Errata to IEEE Guide for Dry-Type Transformer Through-Fault Current Duration

Correction Sheet

Issued 14 December 2006

Figure 2—Category II transformers

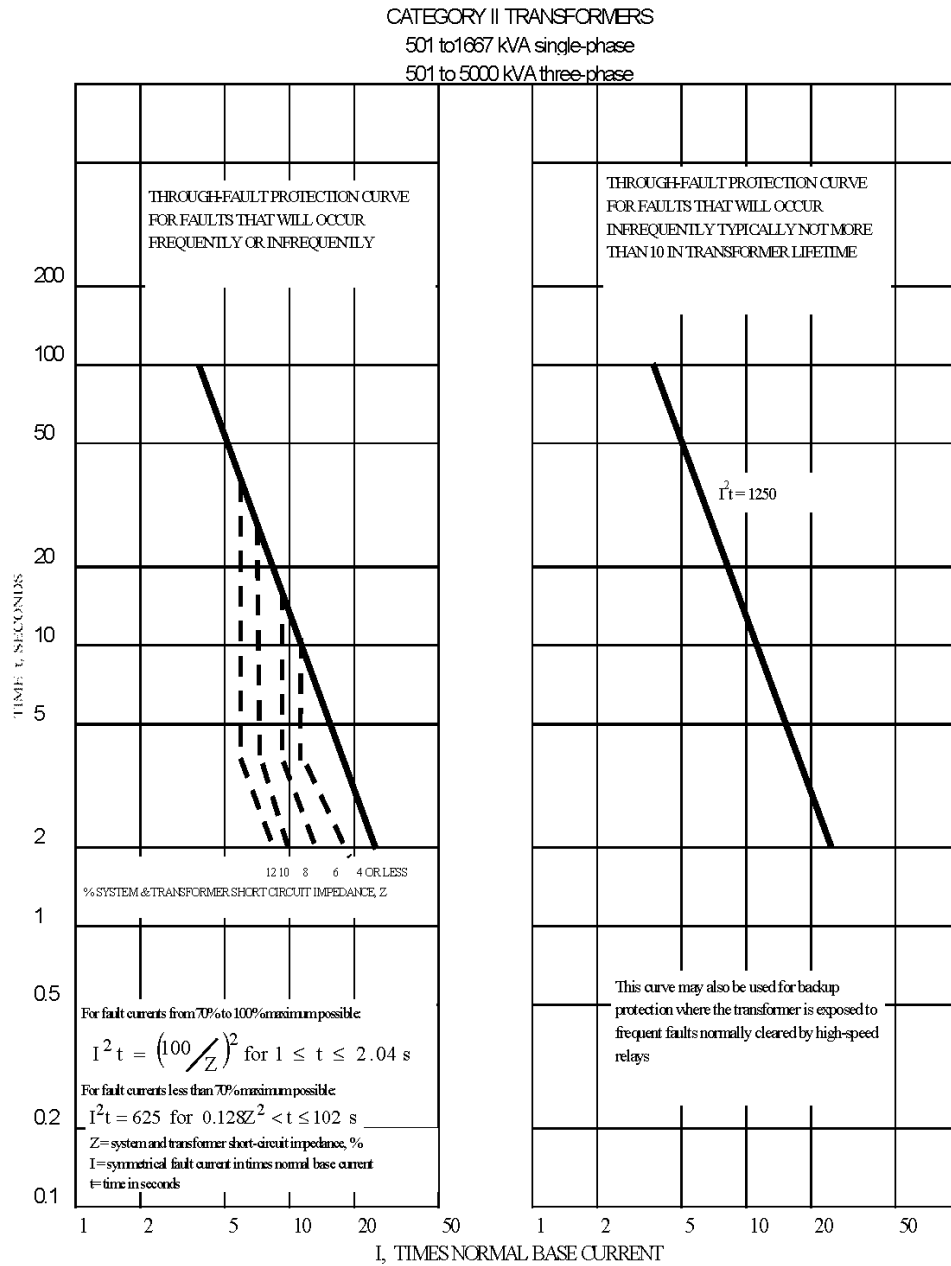
Page 4, Figure 2—Category II transformers, should be replaced with the following figure:
